MARK III

SRVA REVIEW

J. B. HENRY

SEPTEMBER 10, 11, 1980

FOURIER TRANSFORM OF BASEMAT FORCE

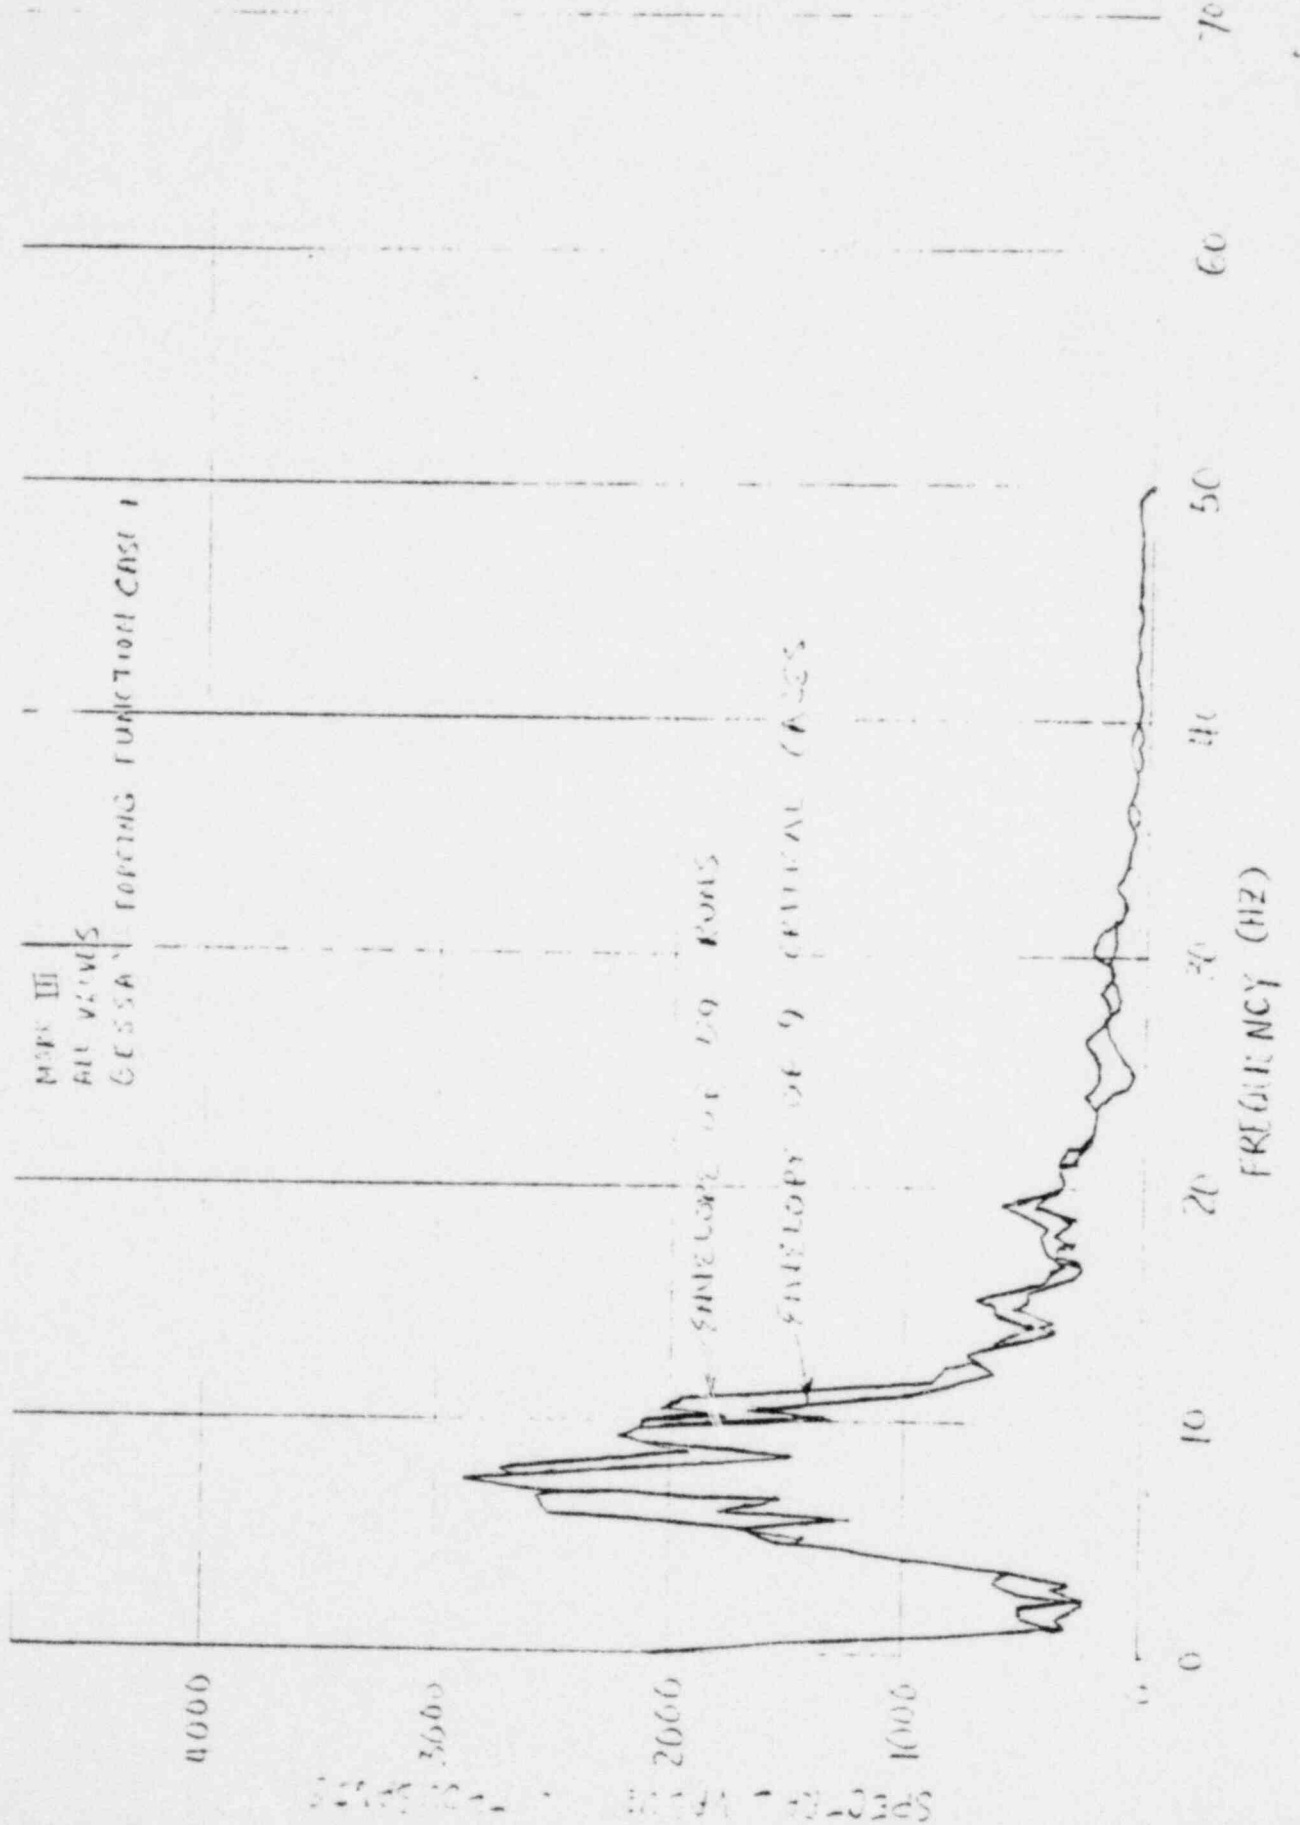
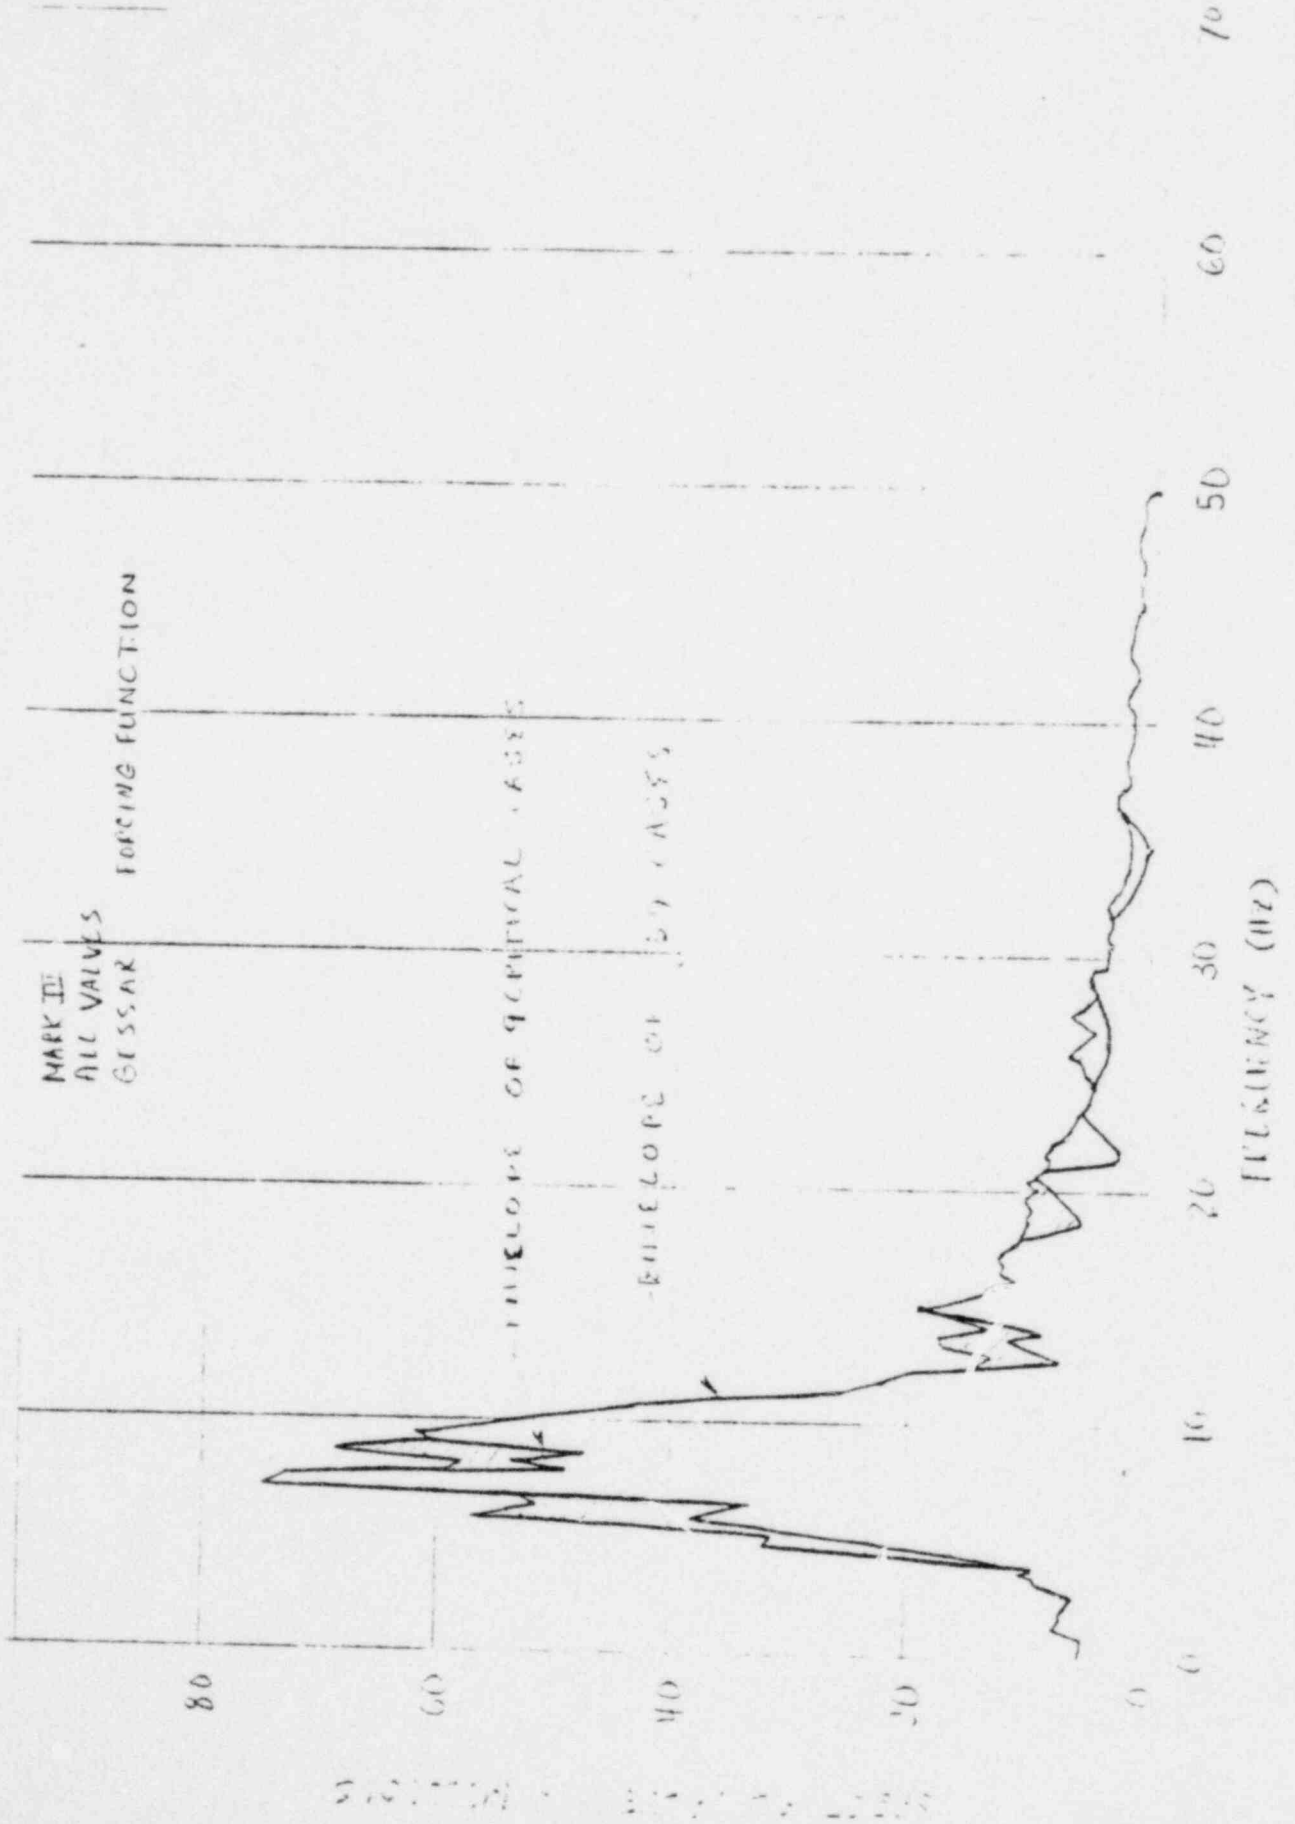
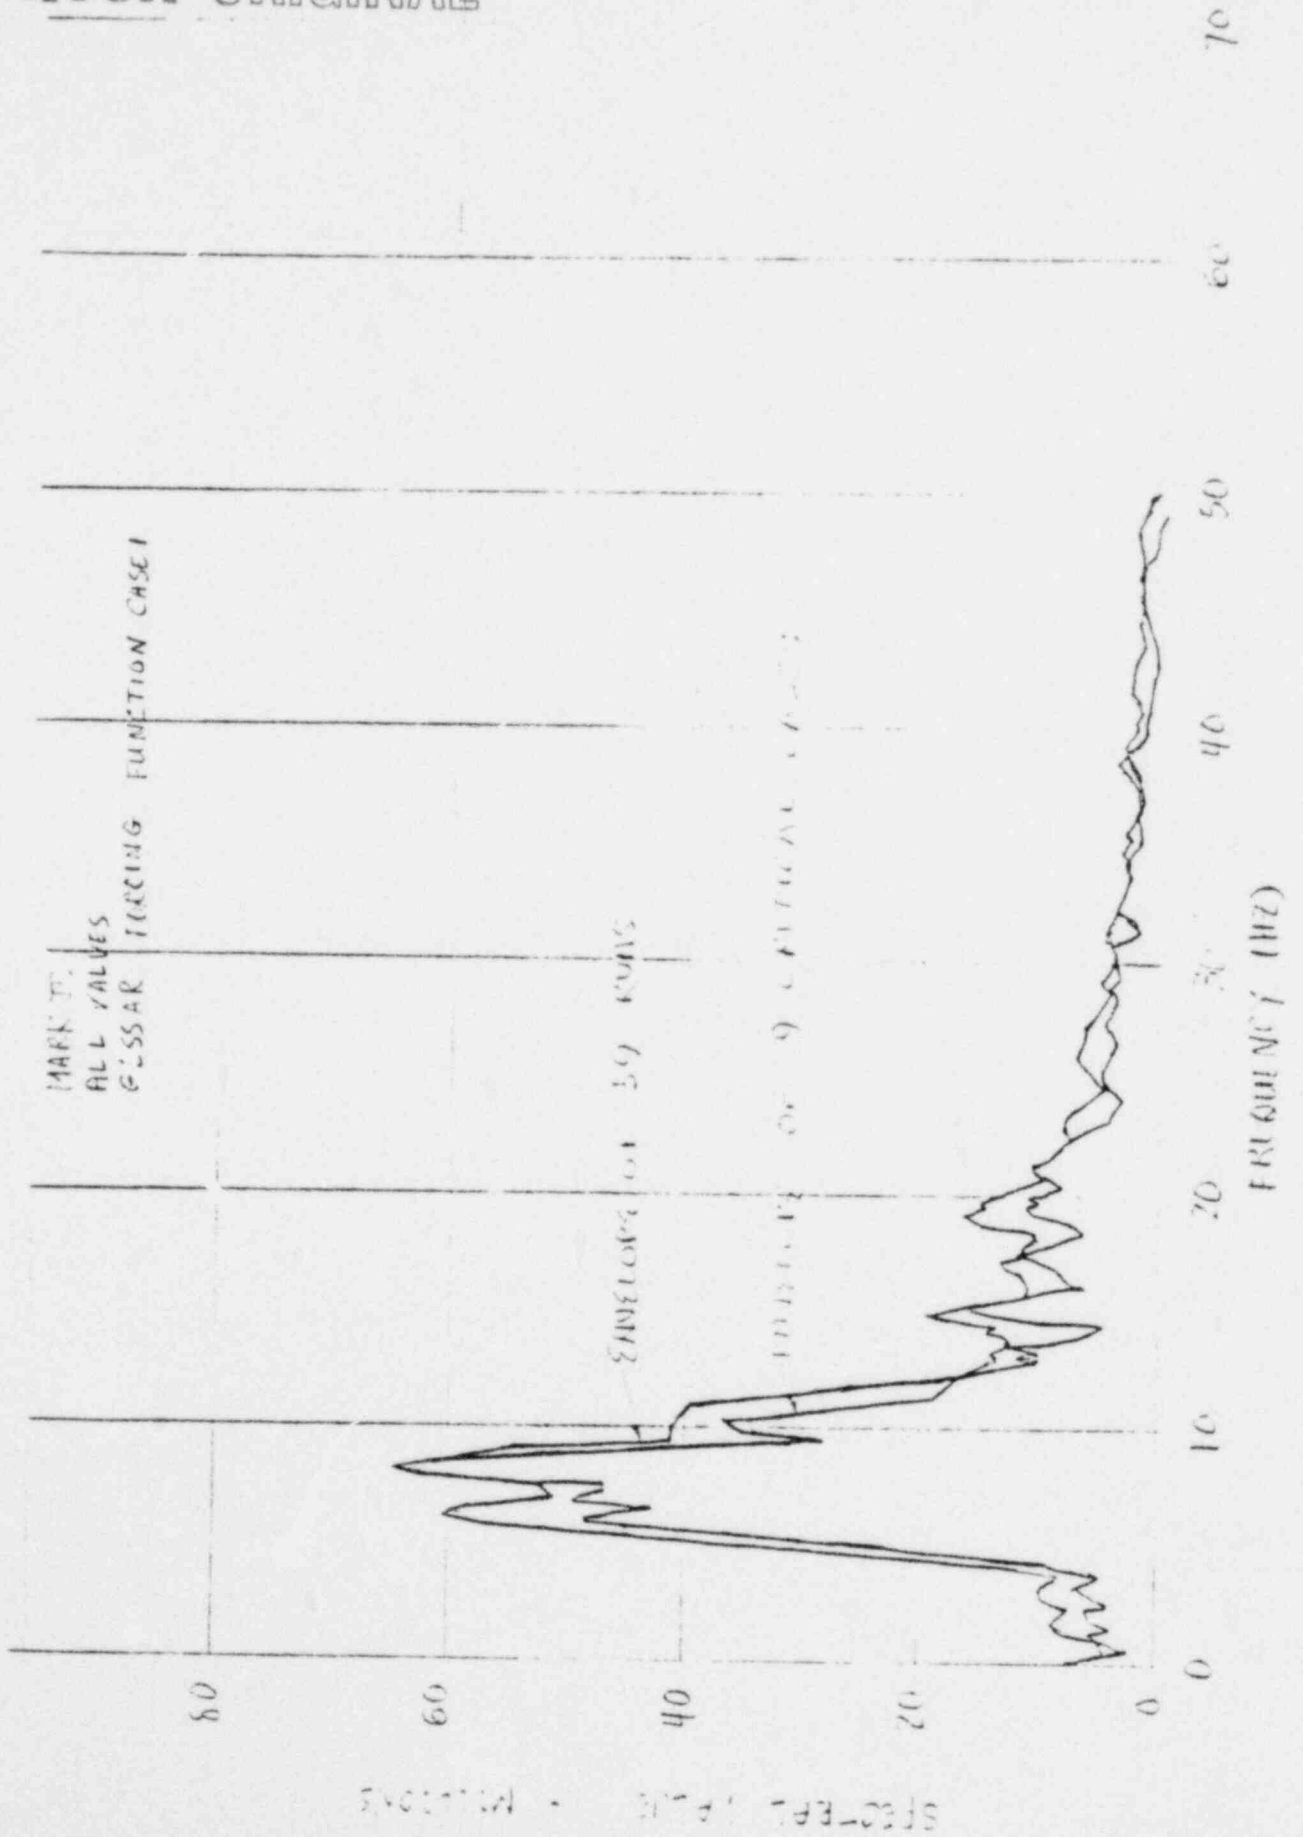
WE BELIEVE THAT ONLY THE PRESSURES ASSOCIATED WITH THE ENVELOPE OF THE FOURIER SPECTRA OF THE 59 MONTE CARLO SIMULATIONS CAN BE CONSIDERED TO BE THE "BOUNDING" FORCING FUNCTION IN THE 95%-95% CONFIDENCE LEVEL SENSE. WE ACKNOWLEDGE THAT SUCH A FORCING FUNCTION CAN BE SYNTHESIZED ADEQUATELY WITH A SUBSET OF THE 59 TRIALS, PARTICULARLY IF SOME FREQUENCY SPREADING OF THE AMPLIFIED RESPONSE SPECTRA (ARS) IS EMPLOYED AT LATER STAGES OF THE ANALYSIS. THE PROCEDURE DESCRIBED TO SELECT THAT FORCING FUNCTION(S) WHICH IS TO BE USED FOR DESIGN DOES NOT APPEAR TO SATISFY THESE REQUIREMENTS. ACCORDINGLY, COMPARE THE SELECTED TRIALS WITH THE FOURIER SPECTRA OF ALL 59 TO SHOW WHAT EXTENT THEY DO OR DO NOT REPRESENT AN ENVELOPE.

- THE REQUESTED COMPARISON HAS BEEN PROVIDED
- THE GESSAR RUN SELECTION METHOD PROVIDES A GOOD APPROXIMATION TO THE ENVELOPE OF SPECTRAL PEAKS FROM 59 RUNS
- PEAK BROADENING OF THE RESPONSE SPECTRA WILL PROVIDE FURTHER BOUNDING OF THE ENVELOPE
- NOT APPROPRIATE TO USE PRESSURES ASSOCIATED WITH THE ENVELOPE
 - NOT REPRESENTATIVE OF AN SRVA EVENT (WRONG TIME HISTORY)
 - ENERGY CONTENT IN THE ENVELOPE IS THREE TIMES THE AVERAGE
